12 / AUT 12

CERTIFICATE OF JUMPING HILL CERTIFICAT DE CONFORMITE **SCHANZENPROFILBESTÄTIGUNG**

Villach

HS 98

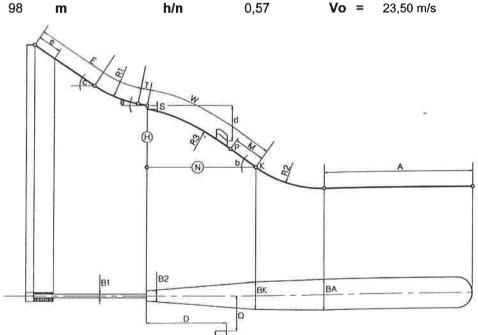
- 1. inspection by Marko Mlakar (14th July 2014)
- remarks of inspection-report from 14th July 2014 must be observed,
- 3. a security-sub-cunstruction over the tarpauline-roll must be installed to protect falling athletes
- missing data "RP" must completed until July 1015
- certificate is only valid after worked out these remarks.

in outrun closed guard-rails must be fixed in accordance to IWO 411.5.2 during competition, net is not permissible between infield and visitors area.
